ALBERTA TRANSPORTATION SPRINGBANK OFF-STREAM RESERVOIR PROJECT
RESPONSE TO NRCB AND AEP SUPPLEMENTAL INFORMATION REQUEST 1, JULY 28, 2018

Dam Safety
May 2019

Figure IR528-2 Modelling Output for the Diversion Structure Hydrographs

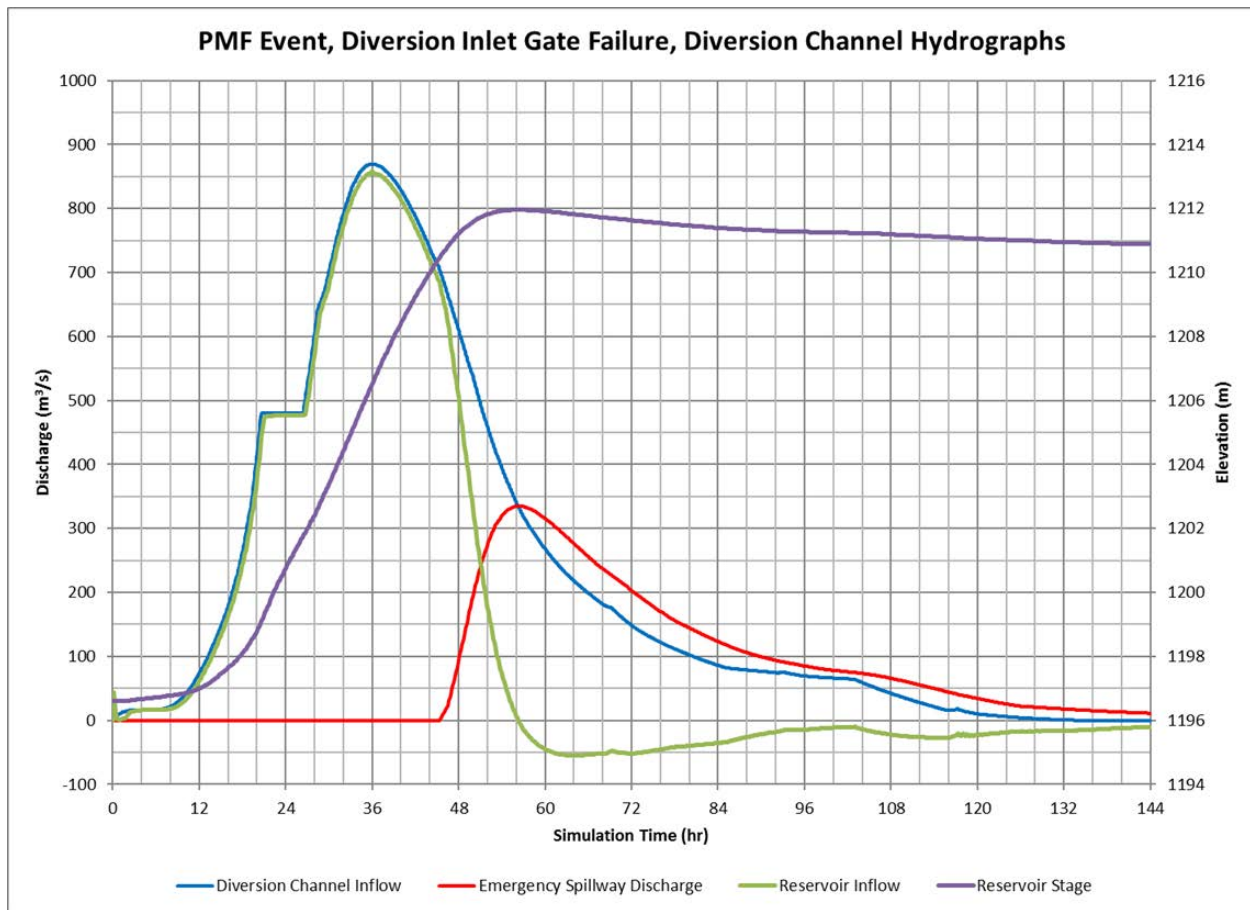
- e. **Why is the reservoir inflow shown on Figure 39 consistently slightly less than the diversion channel inflow even when the emergency spillway is not operating?**

The HEC-RAS model simulates the unsteady flow hydraulics of the diversion channel and the elevations of the reservoir for the calculated inflow hydrograph from the HEC-ResSim model. The emergency spillway is modelled as a lateral weir within the channel. The reservoir is modeled as a storage area at the end of the channel and provided with a stage-storage relationship. The results of the HEC-RAS model simulation are presented in Figure IR528-2.

Based on the simulation results, the maximum reservoir water level is calculated as El. 1,212 m.
